Appendix G to Final Report: Meeting Records

Los Padres Dam and Reservoir Alternatives and Sediment Management Study

Meeting Record - TRC Meeting No. 1

Project:	Los Padres Dam and Reservoir Alternatives and Sediment Management Study	
Subject:	Technical Review Committee Meeting No. 1 – Study Preparation	
Date:	Thursday, August 03, 2017	
Time	9:00 AM to 3:00 PM	
Location:	AECOM at the Kaiser Center, 300 Lakeside Drive, Suite 400, Oakland, CA 94612 – Bella Vista Room	
Attendees:	<i>Ethan Bell, Stillwater (by phone)</i> <i>Madeleine Bray, AECOM</i> <i>Joel Casagrande, NMFS</i> <i>Shawn Chartrand, Balance</i> <i>Brian Cluer, NMFS</i> <i>Larry Hampson, MPWMD</i> <i>Shannon Leonard, AECOM</i>	<i>Dennis Michniuk, CDFW (by phone)</i> <i>Kealie Pretzlav, Balance</i> <i>John Roadifer, AECOM</i> <i>Dave Stoldt, MPWMD (by phone)</i> <i>Jon Stead, AECOM</i> <i>Kevan Urquhart, MPWMD</i> <i>Marcin Whitman, CDFW</i>

Los Padres Reservoir Dry Season In-Flows: 1995-2007
Flow on or About the First Weekday of the Month

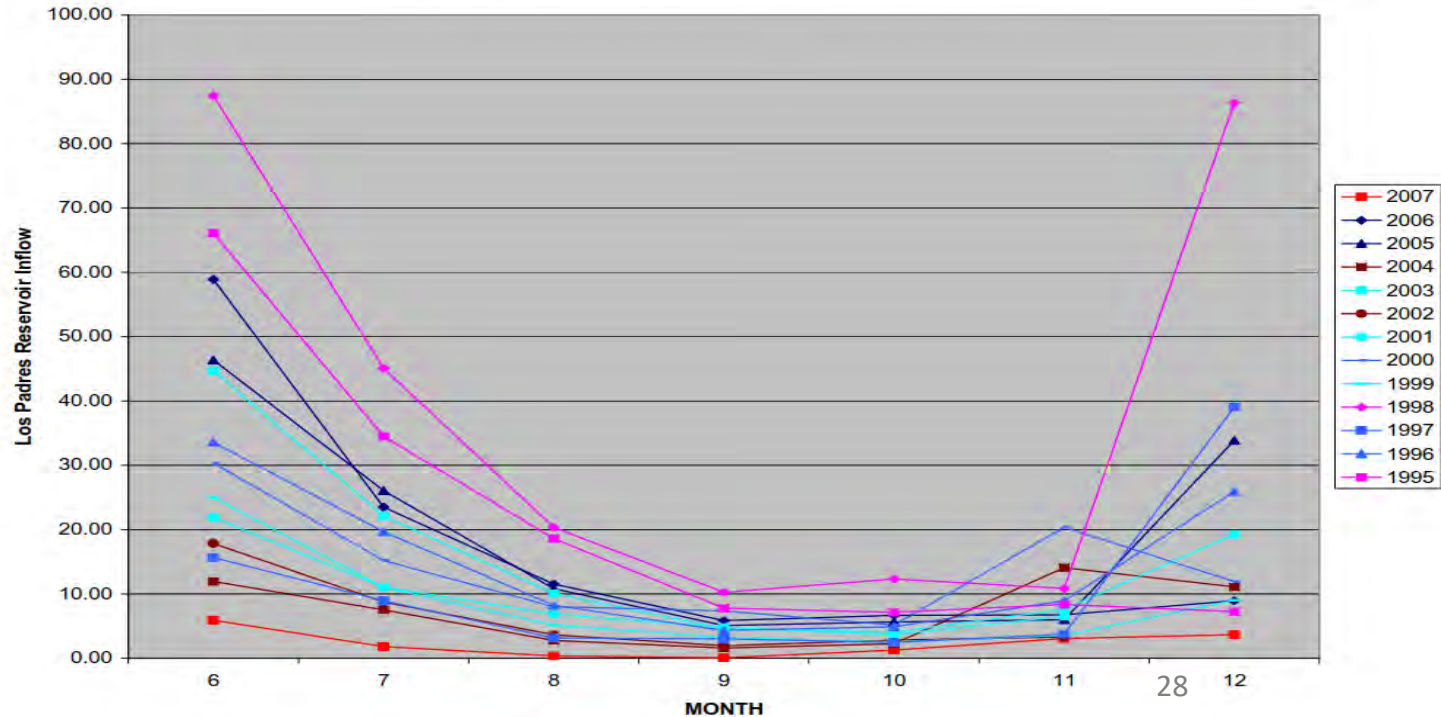
- ii. *Reservoir inflow is measured monthly by MPWMD upstream of Los Padres Dam. MPWMD will send more recent data to Consultant Team to add to graph (see slide 28). It was noted that dry years build on each other (and vice versa for wet years), so the data should not be considered on an annual basis but rather in the context of previous years. Instantaneous flows were also discussed and MPWMD noted that the dam has no meaningful impact on the peaks in these measured flows as they are functionally unimpaired.*

Instantaneous flows at MPWMD gage below LPD (WY 2002-2016)

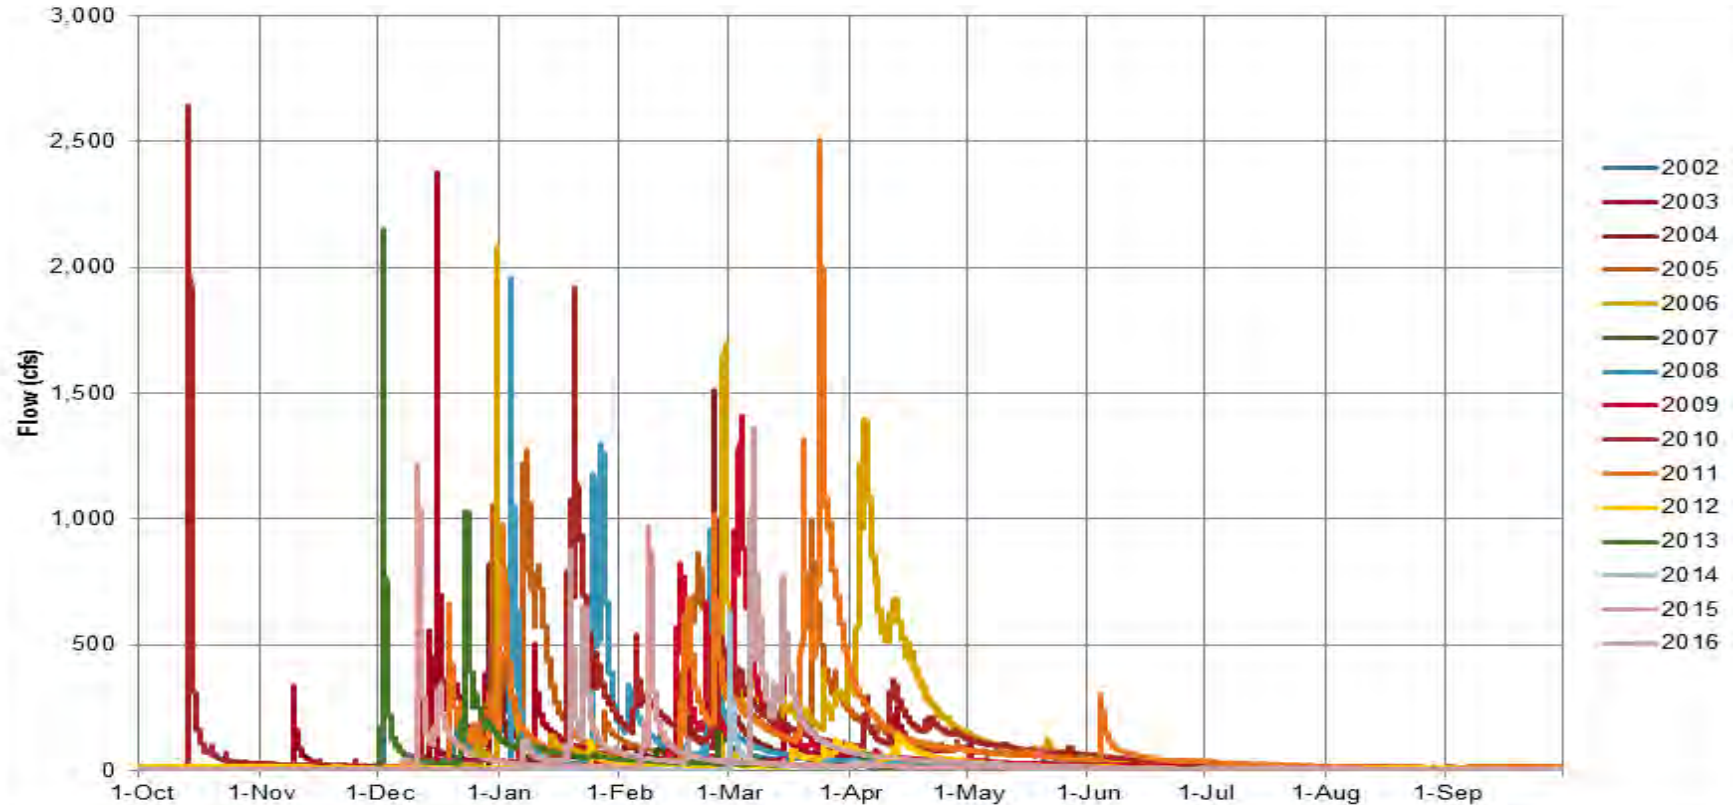
No.	Date	Action	Primary Responsible		Due Date	Status
			Firm/Org.	Individual		
19	8/3/2017	Provide comment on or additional information to reevaluate flood frequency analysis shown for Los Padres Dam gage on slide 31 of TRC M1 presentation, and Table 2-6 and Figure 2-22 on p. 2-49 of the draft Study Preparation TM.	MPWMD	L. Hampson	8/11/2017	Done
22	8/3/2017	Provide grant reports on gravel augmentation conducted by MPWMD.	MPWMD	K. Urquhart	8/18/2017	Done
25	8/3/2017	Provide grain size distribution curves from latest data evaluated for use in sediment transport analyses, to evaluate adequacy as compared to data in URS 2012.	Balance	S. Chartrand	8/11/2017	Superseded
3	3/10/2017	Provide MPWMD report analyzing evapotranspiration and losses from reservoir storage.	MPWMD	L. Hampson	3/17/2017	In Progress
4	3/10/2017	Provide full size pdf of Los Padres Reservoir original ground topography.	MPWMD	L. Hampson	3/17/2017	In Progress

Stage-storage based on latest information

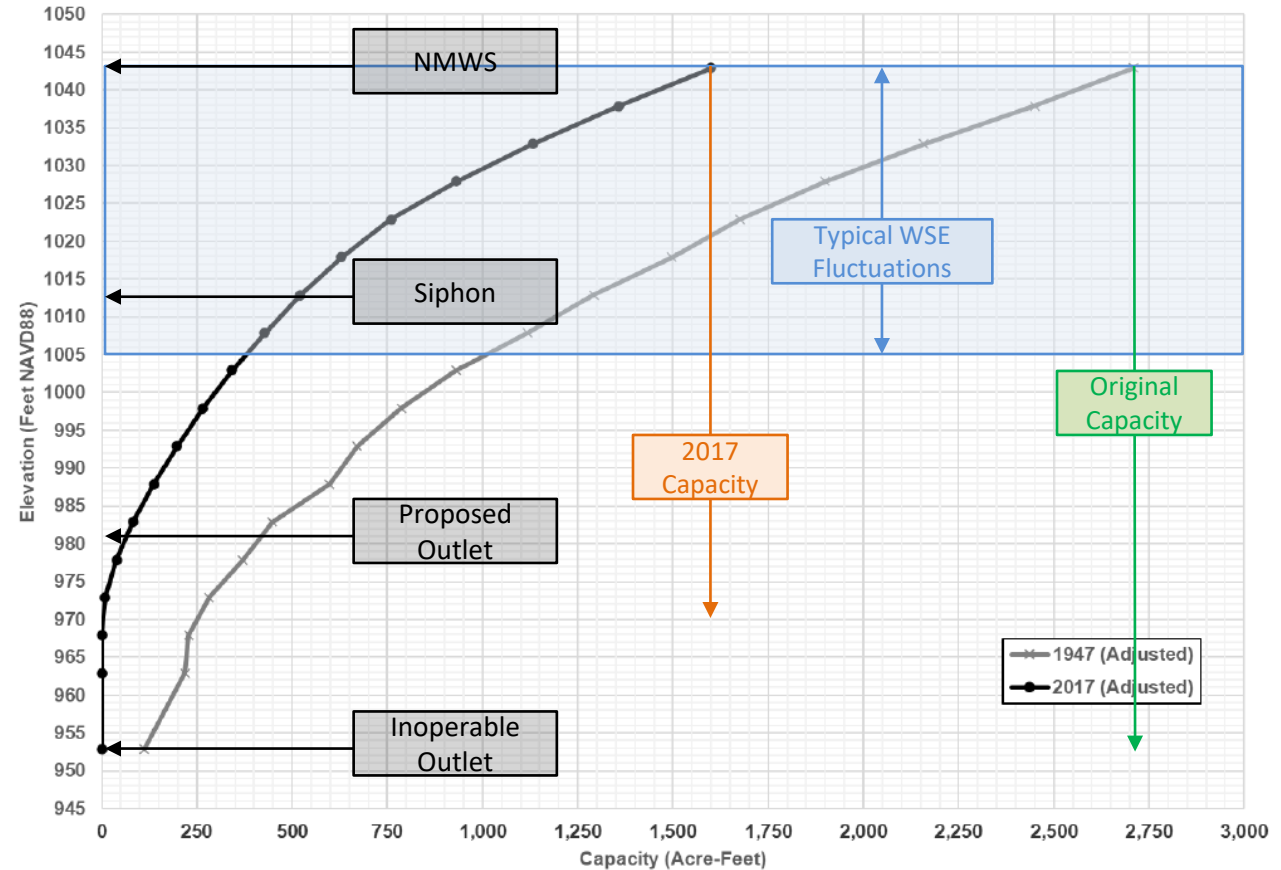
- v. *The stage storage curve was discussed and relevant elevations clarified (see slide 14). It was noted that the elevation of the fish bypass pipe should be included on the stage storage curve.*
 - vi. *In past dry years, large debris has been an issue with clogging the outlet pipe when the water surface elevation was drawn down very low. Divers were required to remove the debris once water elevations were restored. Historically, fine sediment has not caused clogging of the outlet.*
 - vii. *Low flow conditions and the impact to reservoir operations were discussed.*
- b. Carmel River response reaches (slides 18-25)
